**SUBJECT: NEW VEHICLE DEMONSTRATION / DELIVERY HOLD
Compliance Recall 23C25 - *Supplement #2***
Certain 2023 Model Year Super Duty and Escape Vehicles
Instrument Panel Cluster Replacement

New! REASON FOR THIS SUPPLEMENT

FIGURE 1

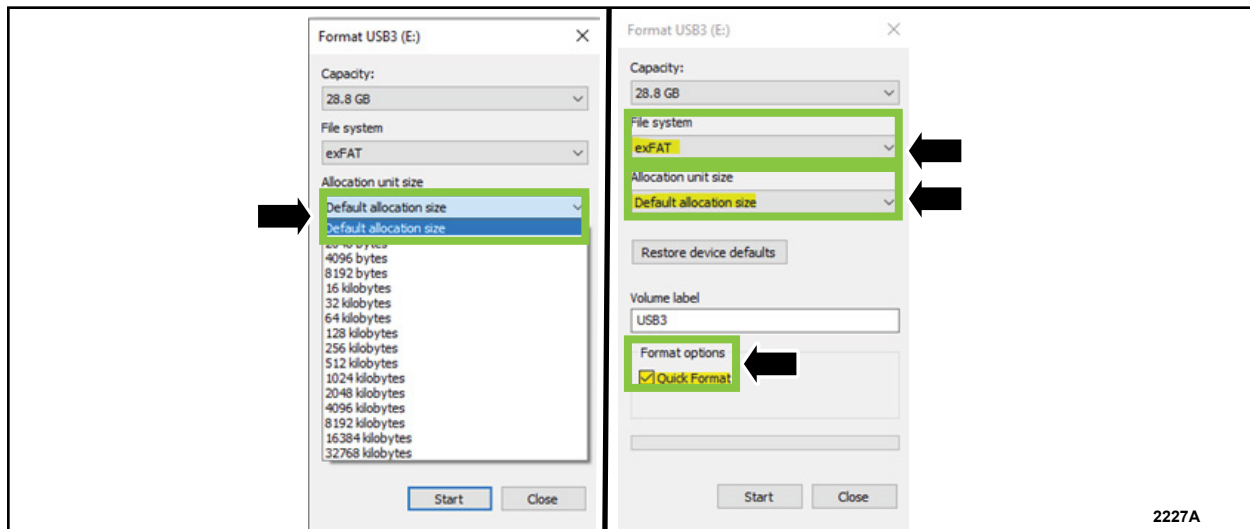
10. Perform the Module Software Updating Procedures outlined below for the GWM module:
Perform a network test after each software update using the latest software level of the FDRS scan tool. This will refresh the list of modules that have available software updates based on current module software levels. Continue performing software updates to the GWM module until all software updates are complete. If any error conditions are experienced during programming, refer to WSM Section 418-01A > General Procedures > Module Programming for the Error Condition Table.

NOTE: A 64GB or larger USB flash drive is required for APIM, TCU, and GWM software updates. USB 3.0 or higher is recommended. Make sure the USB flash drive being used is formatted correctly. To see the available drives, hold down the Windows icon keyboard key and press the E keyboard key. Right click on the USB flash drive and select Properties. If File System under the General tab is not exFAT, the drive must be formatted.

FIGURE 2

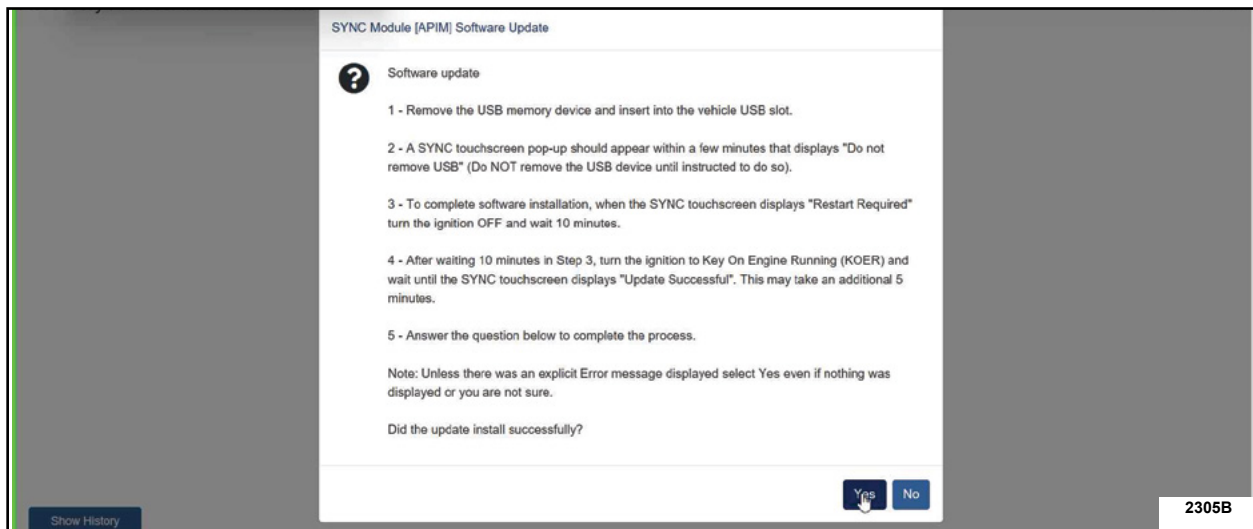
29. Select Toolbox tab.
30. From the list on the LH side of the screen, select the APIM.
31. From the list on the RH side of the screen, select APIM - Accessory Protocol Interface Module [APIM] Software Update.
32. Click RUN. Follow all on-screen instructions carefully.
33. Return the USB thumb drive to the FDRS and follow the on-screen prompts carefully until the following screen is reached. See Figure 2.
